NUCLEAR REGULATORY COMMISSION

Title: Advisory Committee on Reactor Safeguards
Subcommittee on Future Plant Designs

Date: Friday, July 18, 2003

Figure 8.6.1 AP1000 Bounding Analysis Curve for 8" CMT, DVI, IRWST
 (Line Numbers: L015A,016A,018A,020A,021A-No Insul.,025A,125A,127A)

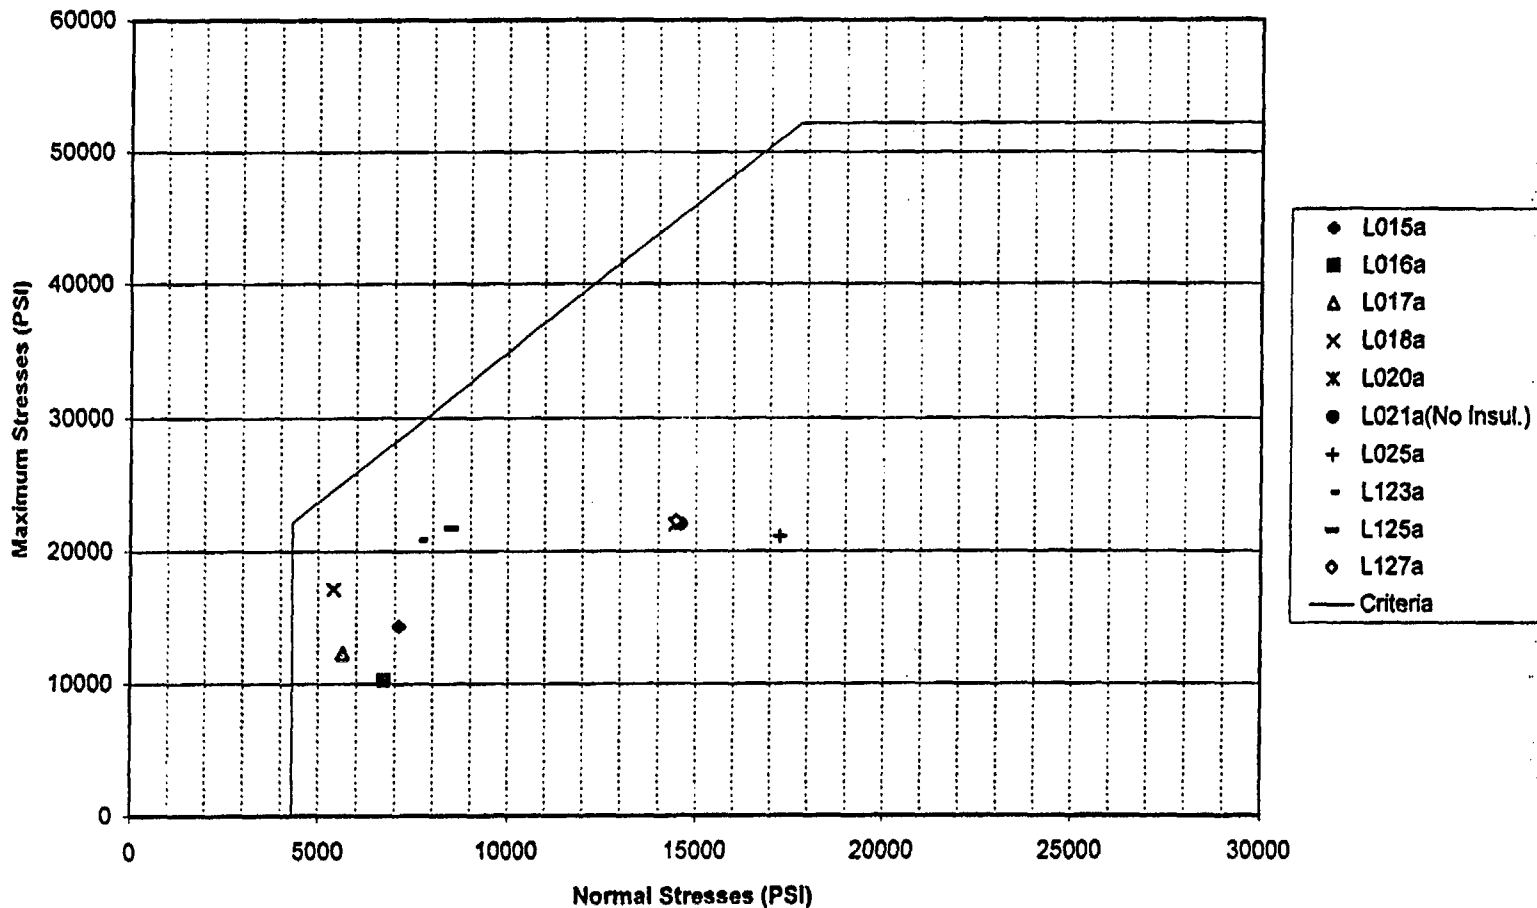
- To resolve this issue, Westinghouse has proposed to complete a Preliminary piping stress analysis for NRC review
- DVI-A Piping Analysis Package
 - Selected based on our experience with AP600
 - Difficult to qualify
 - Complicated piping system
 - Some piping sizes were changed
 - Contains smallest piping line qualified for LBB
 - Subcompartment pressurization impacts if line would not meet LBB criteria
